<p>نگهداشت و افزایش تولید میدان نفتی بینک سطح الارض</p> <p>احداث ردیف تراکم گاز در ایستگاه جمع آوری بینک</p>																									
<p>شماره پیمان: ۰۵۳ - ۰۷۳ - ۹۱۸۴</p>

<table><tr> <th colspan="8">HAZOP REPORT FOR COMPRESSOR STATION</th> </tr><tr> <td>D00</td> <td>0004</td> <td>RT</td> <td>GE</td> <td>120</td> <td>PEDCO</td> <td>GCS</td> <td>BK</td> </tr></table>

The purpose of this document is to provide the results of “HAZOP Study” for **Binak Oilfield Development – Surface Facilities; New Gas Compressor Station**.

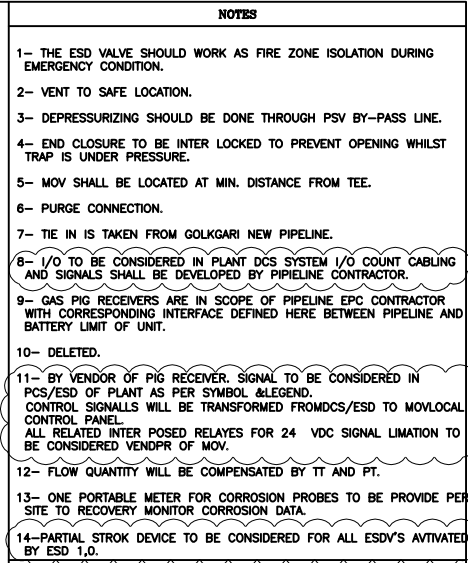
8. Show on P&ID (BK-GCS-PEDCO-120-PR-PI-0003) purge connection of Golkhari line at min distance to barred tee.	Consequences: 2.6.1.1	Contractor	Closed
9. Ball valve on tie-in point of 10" gas pipeline Golkhari BL should be full bore.	Consequences: 2.8.1.1	Contractor	Closed

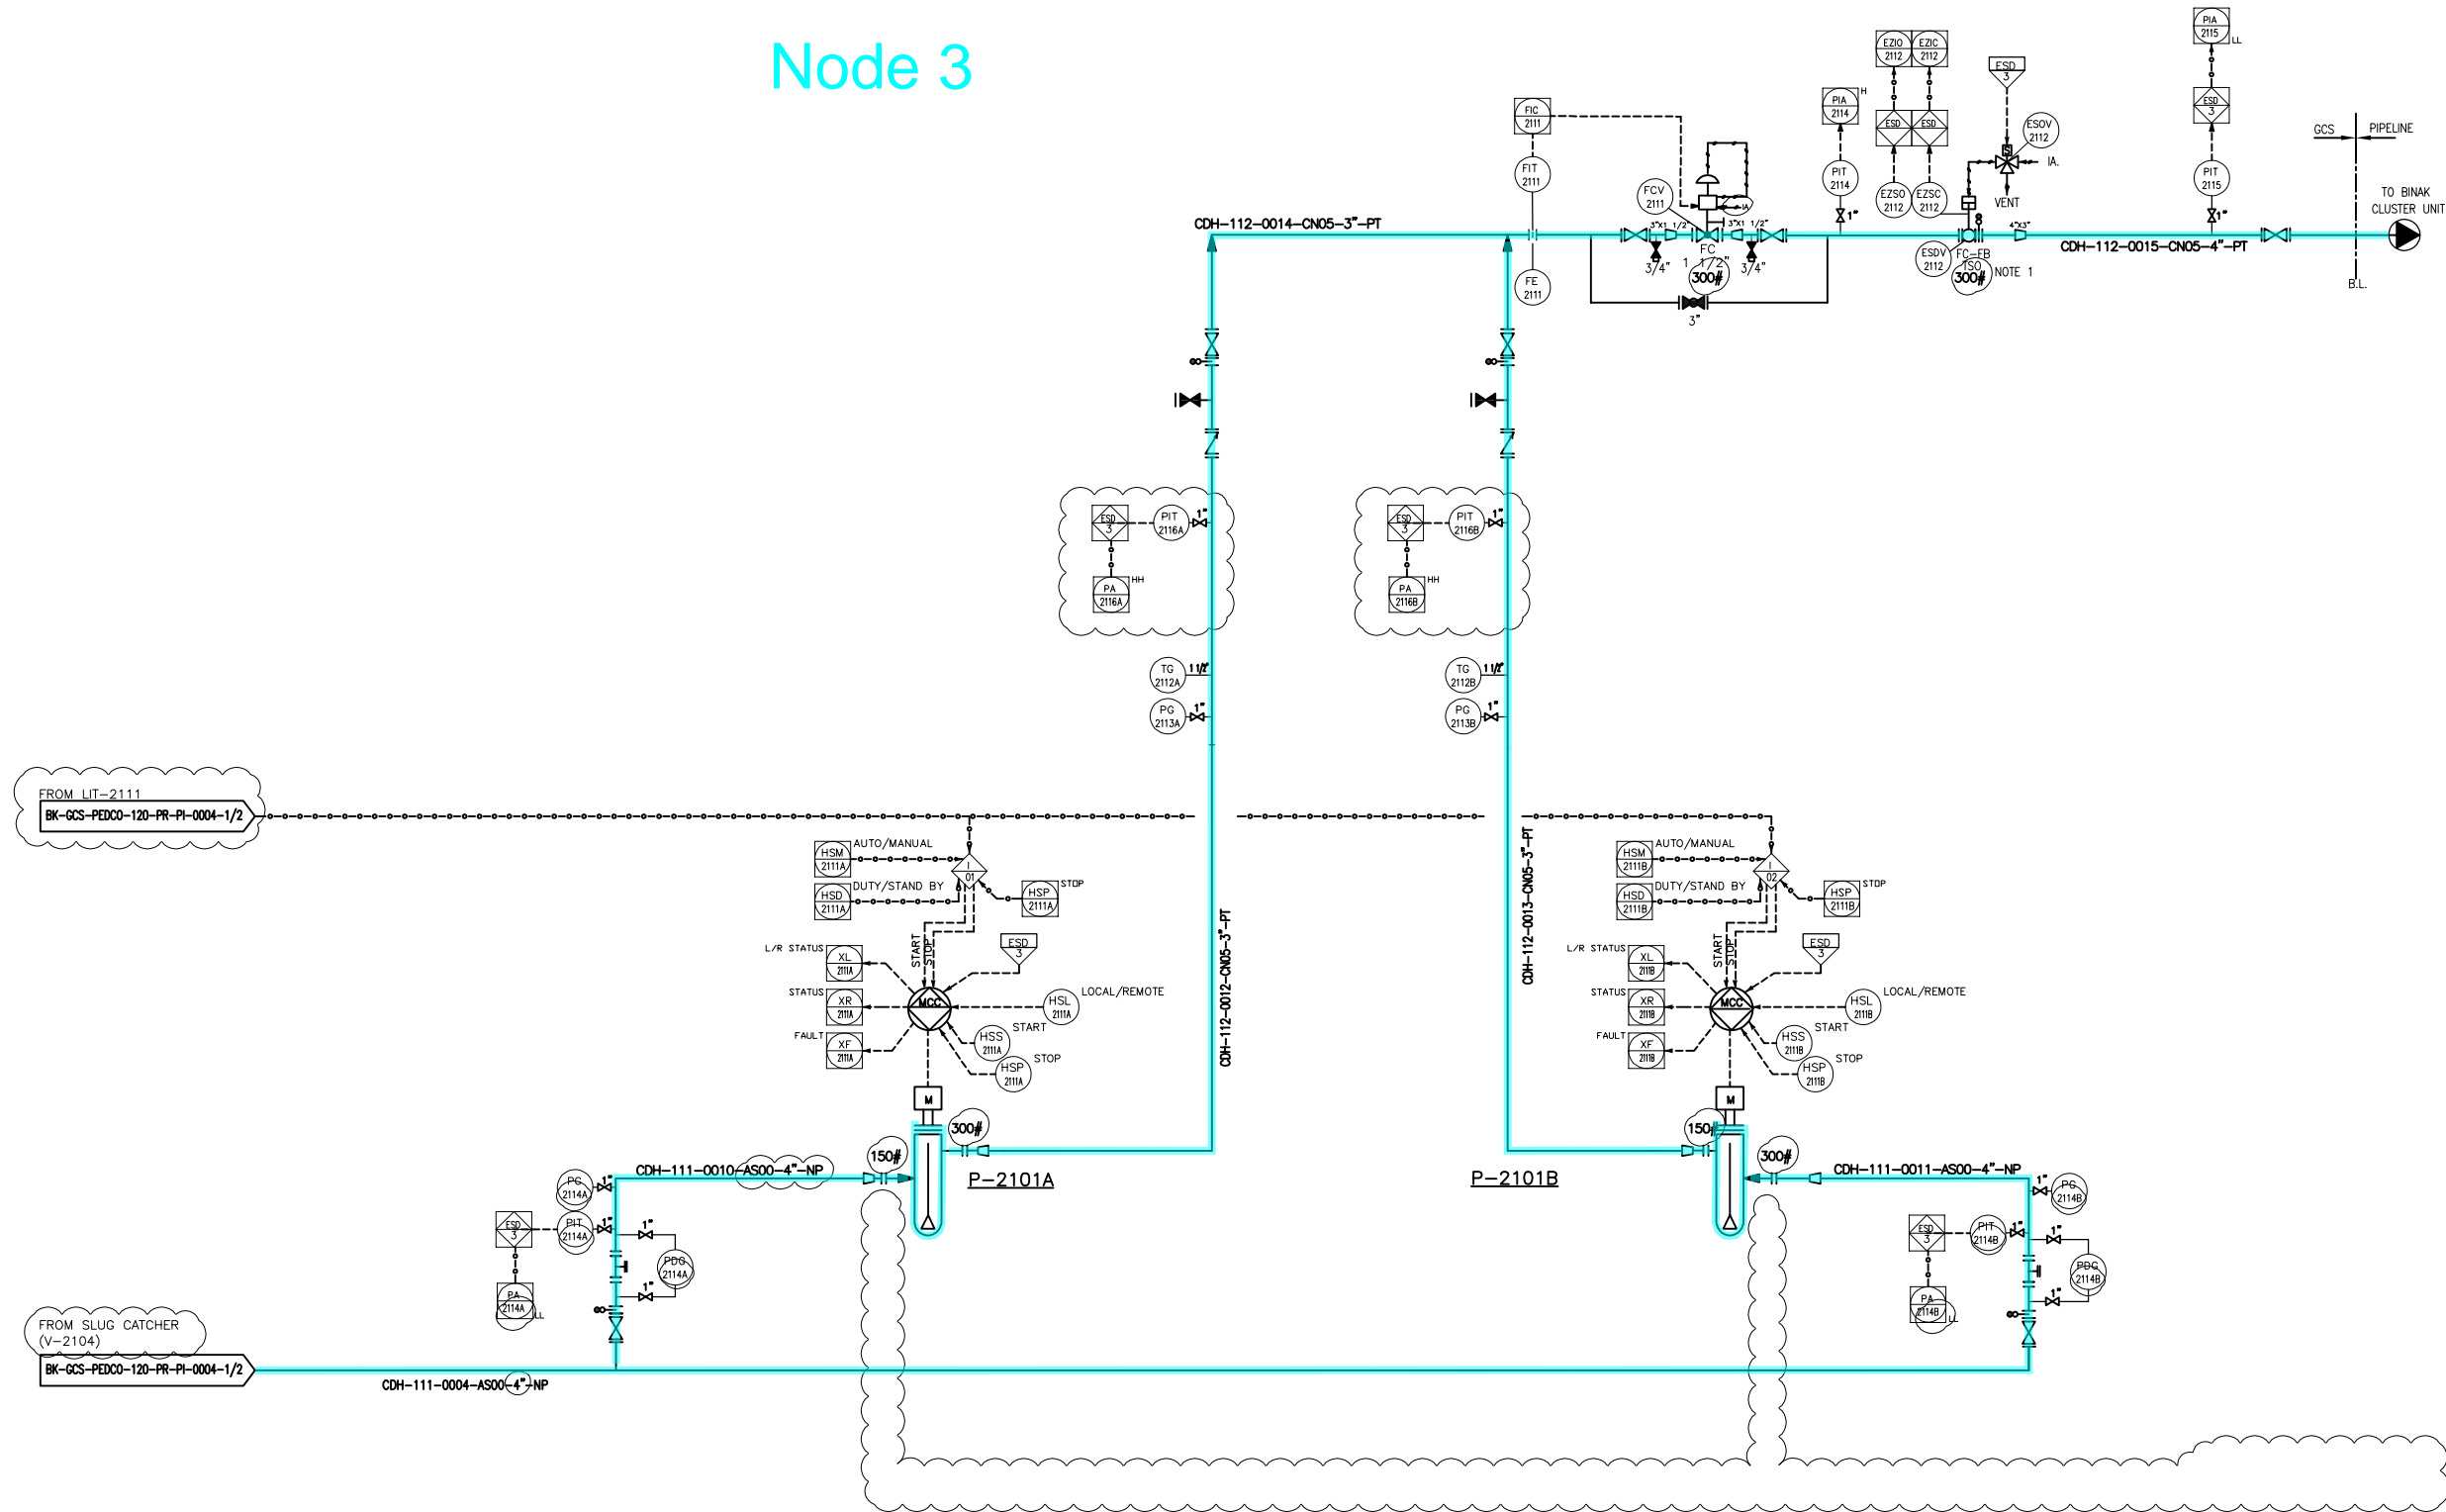
11. Remove auto start signal from LIC-2111 on P-2101A/B.	Consequences: 3.1.1.1	Contractor	Closed
12. Define in operating manual of compressor station that on high level of V-2104 operator shall start P-2101A/B and open ESDV-2112.	Consequences: 3.1.1.1	Contractor	Closed

16. Show on P&ID (BK-GCS-PEDCO-120-PR-PI-0004) pump pit for P-2101A/B.	Consequences: 3.1.6.1	Contractor	Closed
17. Install check valve on 2" line from close drain pump P-2202A/B to V-2104.	Consequences: 3.3.1.1	Contractor	Closed

DRAWING TITLE: P&ID - Gas Compression Inlet Knock Out Drum

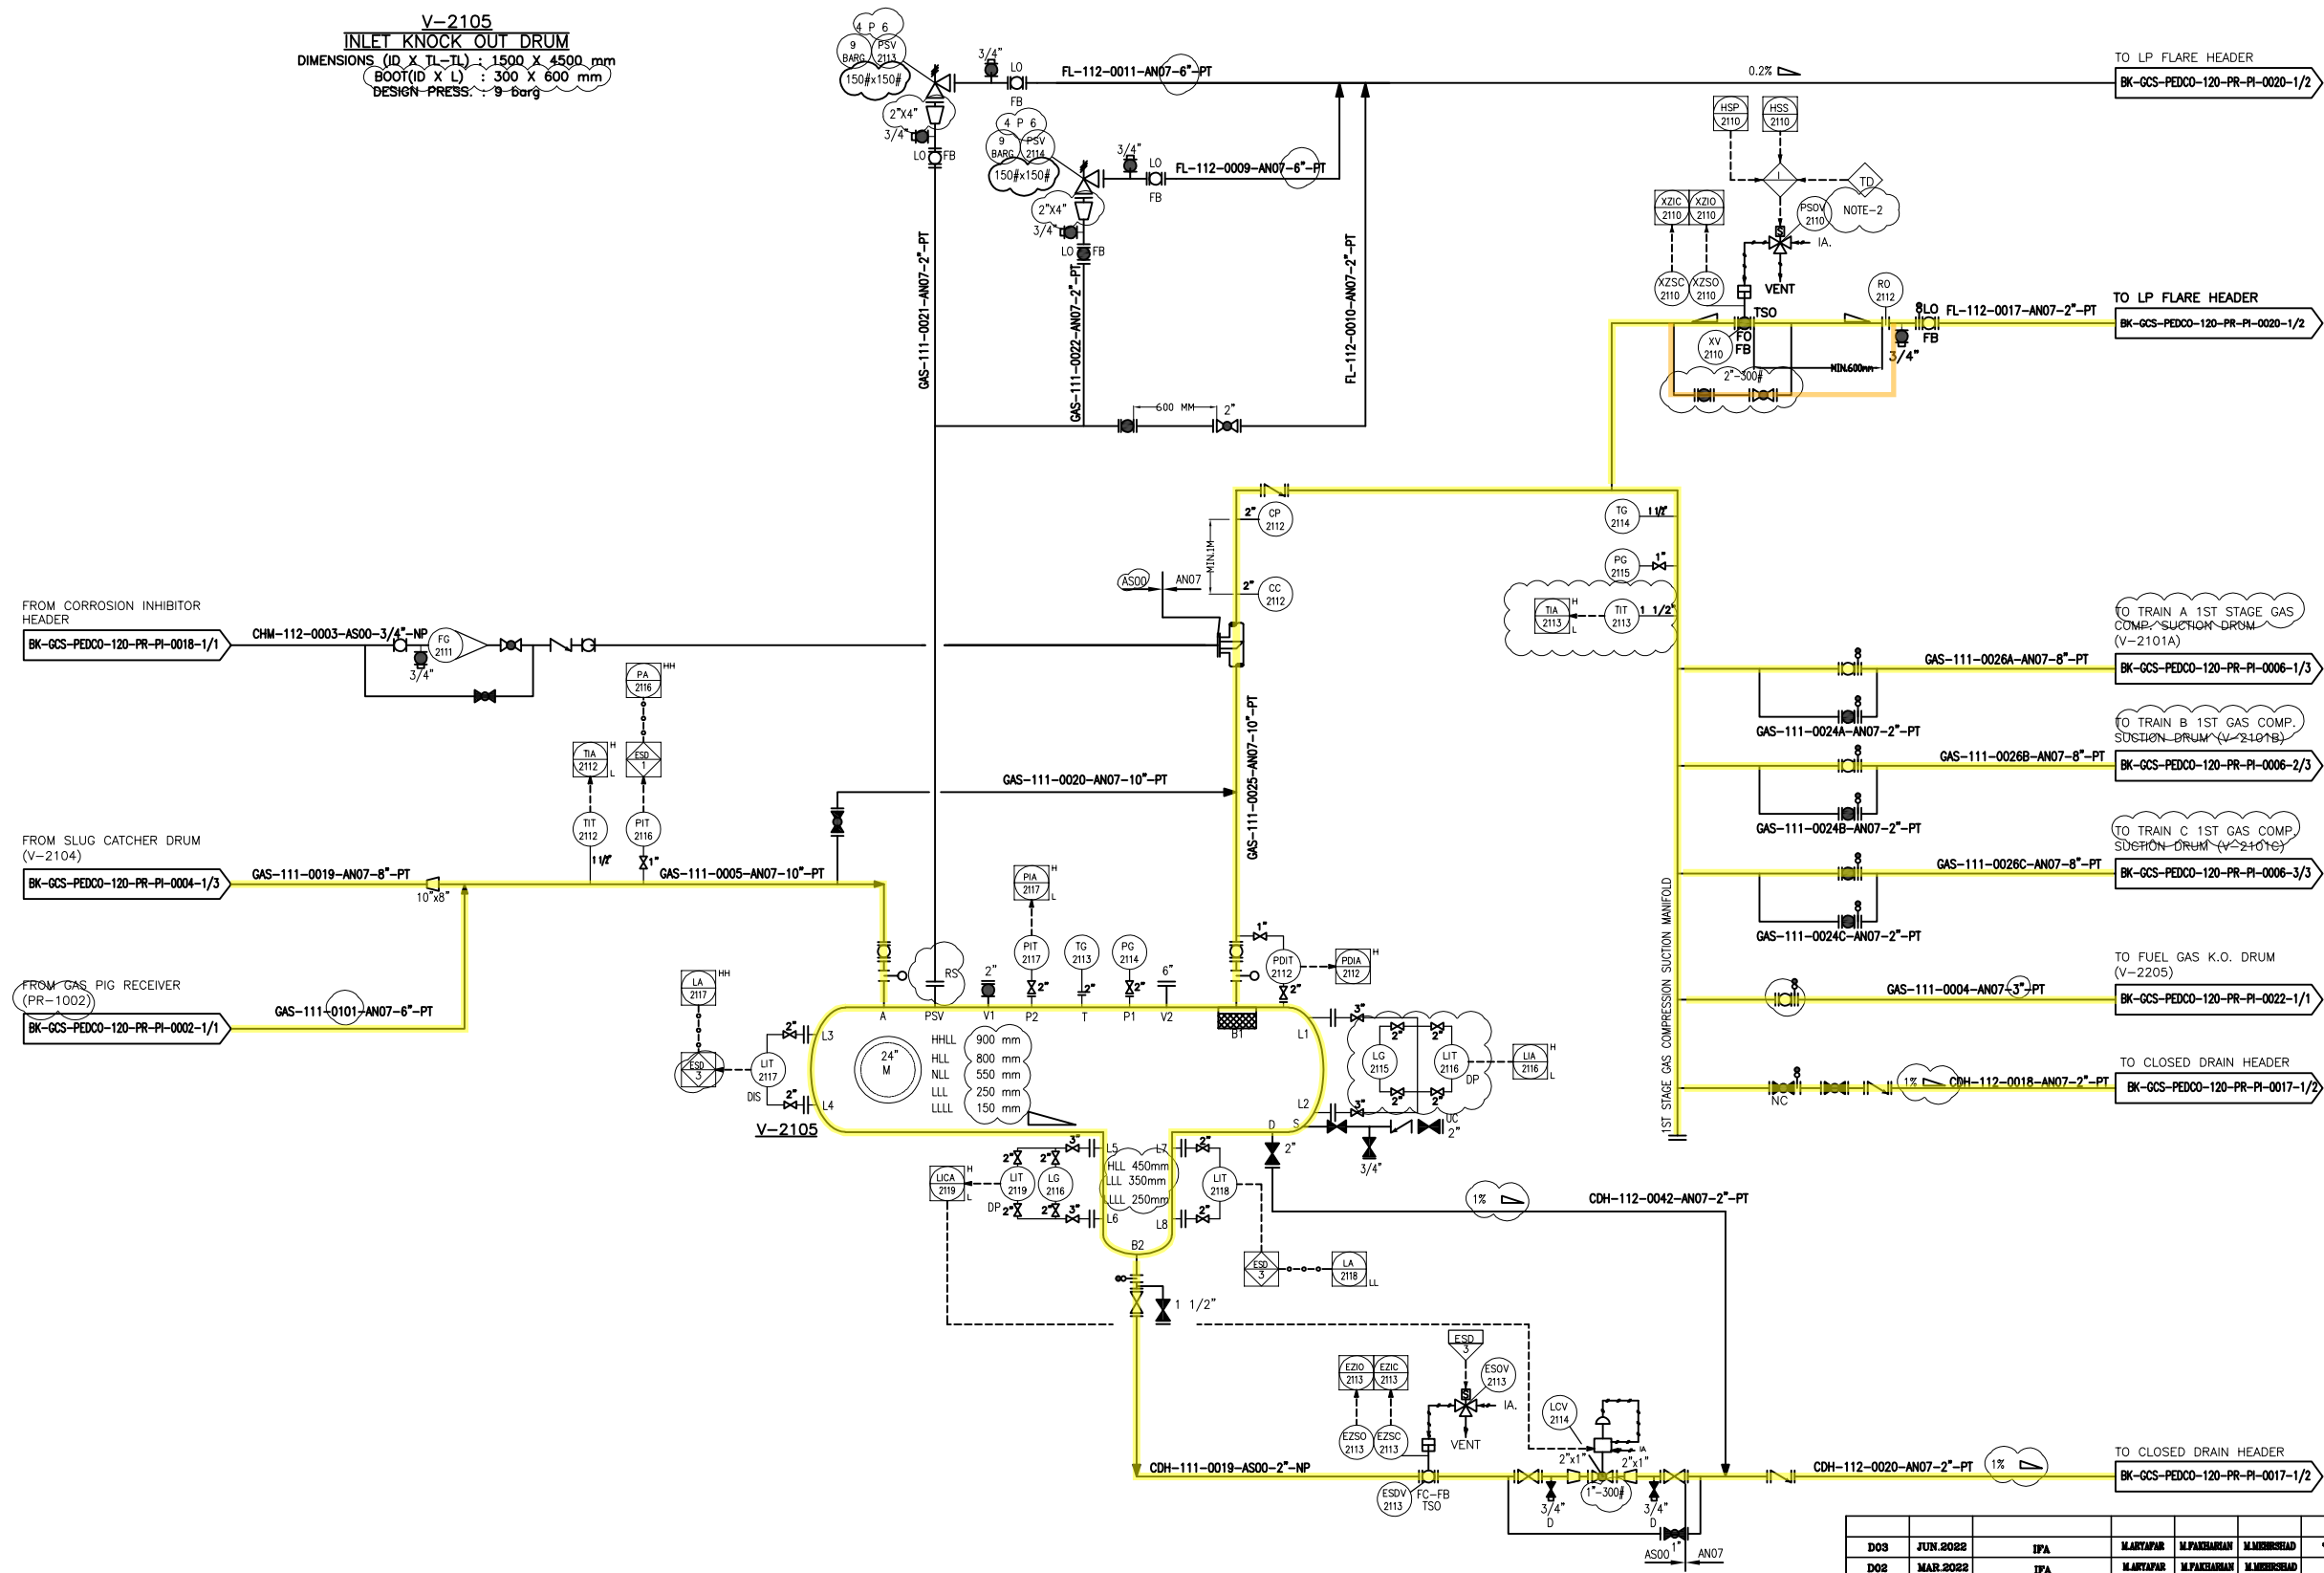
26. Remove bypass over XV-2110.	Consequences: 4.5.2.2	Contractor	Closed
27. LAHH-2117 should activate ESD-1.	Consequences: 4.6.1.1	Contractor	Closed
28. LCV-2114 should be FC.	Consequences: 4.7.1.1	Contractor	Closed

30. Consider spectacle blind on 2" drain line of V-2105, nozzle D.	Consequences: 4.8.1.1	Contractor	Closed
31. Change type of 10" bypass valve over V-2105 to ball type.	Consequences: 4.10.1.1	Contractor	Closed

32. Remove TIT-2111 and TIT-2113.	Consequences: 4.10.1.1	Contractor	Closed
33. Remove LG-2115 and LIT-2116 from V-2105 and connect upper leg of LG-2116 and LIT-2119 to nozzle L1 of vessel.	Consequences: 4.10.1.1	Contractor	Closed
